Microsoft Ireland

DUB14-15

SD21/0203

Pre-Commencement
Submission

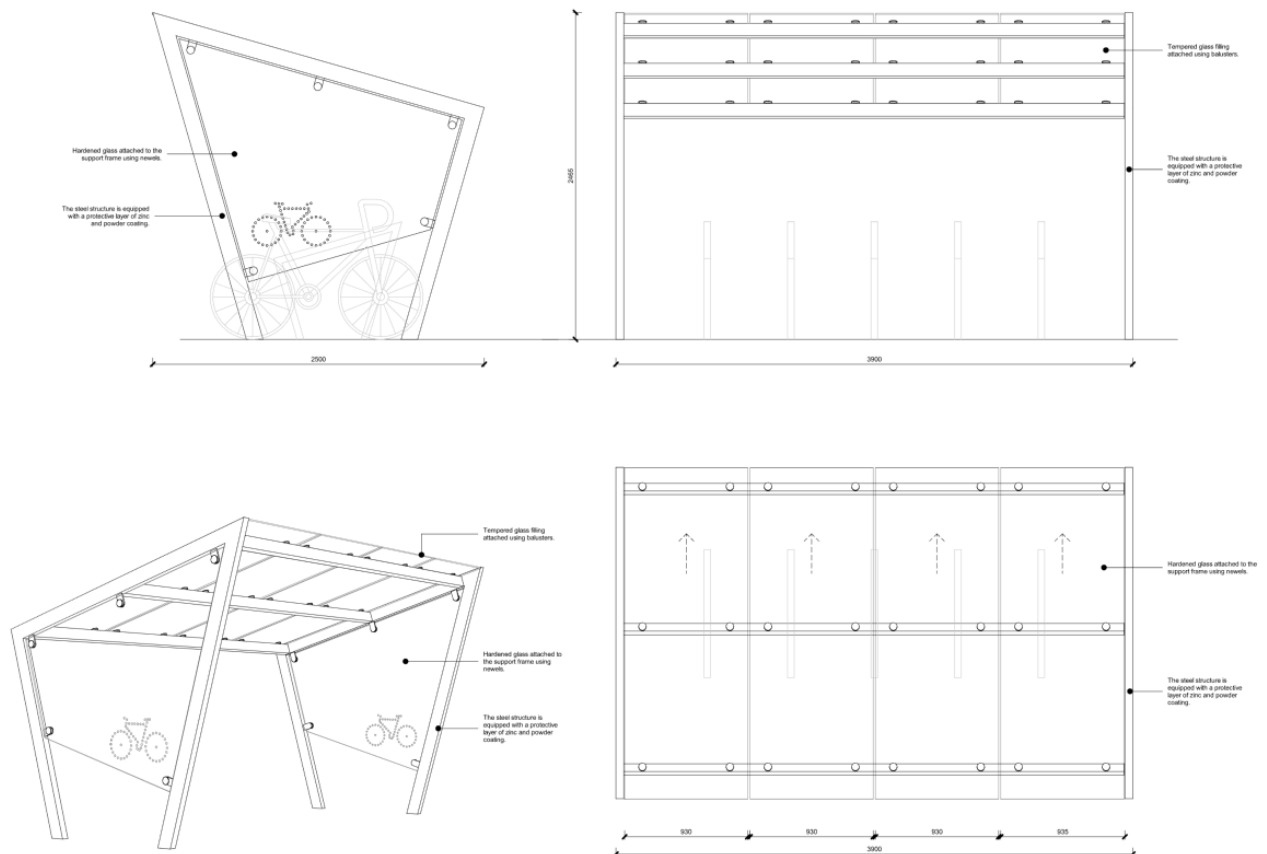
- (1) The proposed development shall make provision for the charging of electric vehicles.*
- (2) 100% of surface car parking spaces shall be provided with electrical ducting and termination points to allow for the provision of future charging points.*
- (3) 10% of surface car parking spaces shall be provided with electric vehicle charging points. **Prior to the commencement of development** details of how it is proposed to comply with Items 1-3, including details of the design of, and signage for, the electric charging points (where they are not in areas to be taken in charge) shall be submitted to, and agreed in writing with, the planning authority **prior to commencement of development**.*

- (1) – Confirmed, provision for charging of electric vehicles shall be made.*
- (2) – This condition is noted and will be complied with. More detailed drawing information, showing the ducting provision will follow the main submission.*
- (3) – Refer to drawing ‘A1014_Enlarged Site Plan - Proposed DUB 15 and Admin Building’ showing car parking layout and location of electric charging points. 154 No surface car parking spaces are provided in total. 36 No parking spaces are electric charging. This represents 23% electric charging spaces. Signage for electric parking spaces shall be per the figure below (as originally included in drawing A1016):*

Agreed and we can confirm that the angle of connection to the Irish Water Sewer has been revised to 45 degrees. See attached extract from Drawing DUB14-15_C_D-X02.2 Proposed Drainage Layout Sheet 2.

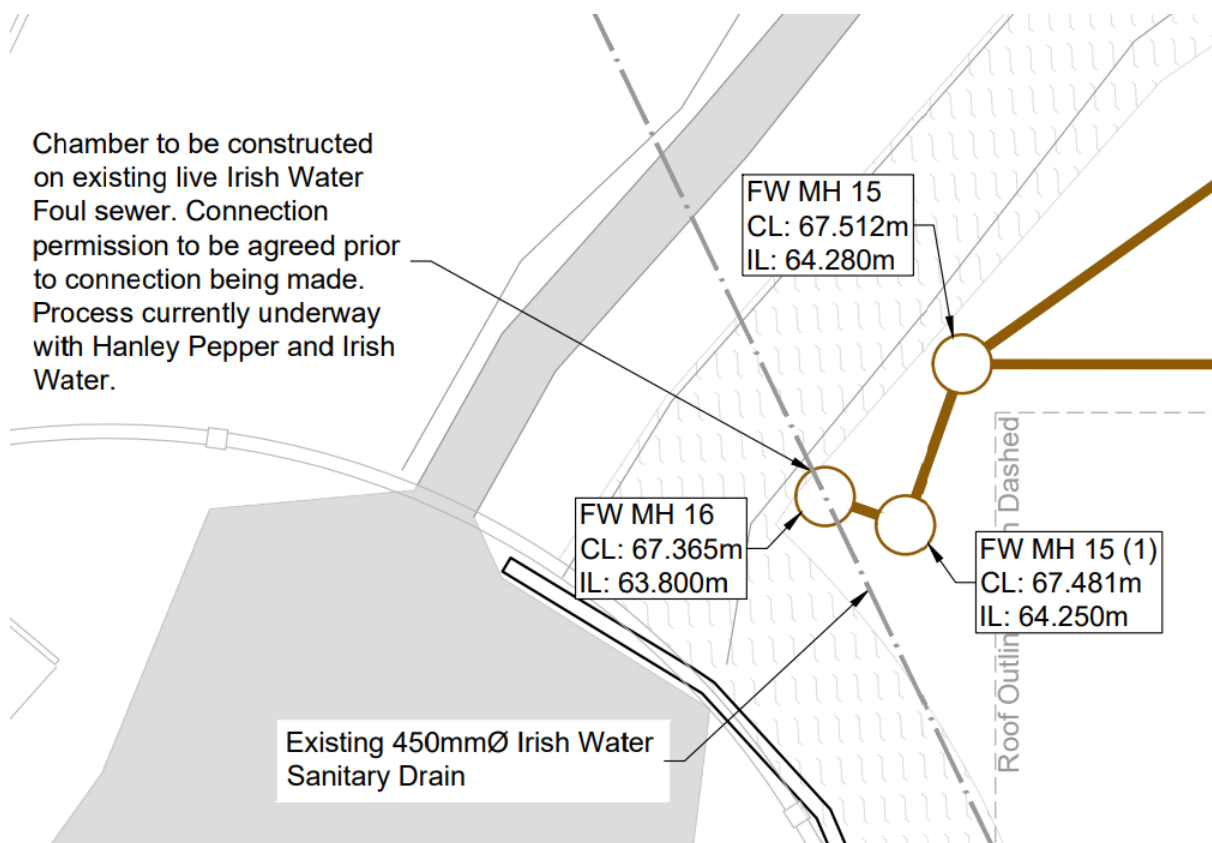
Prior to the commencement of development the applicant shall submit for the written agreement of the Planning Authority a revised wastewater drainage layout drawing showing the angle of connection to the existing public wastewater network being a maximum of 45 degrees and shall be in the direction of flow.

REASON: The proposed connection angle to the existing public wastewater network is too acute and in the interests of public health, the proper planning and sustainable development of the area and in order to ensure adequate water supply and drainage provision.
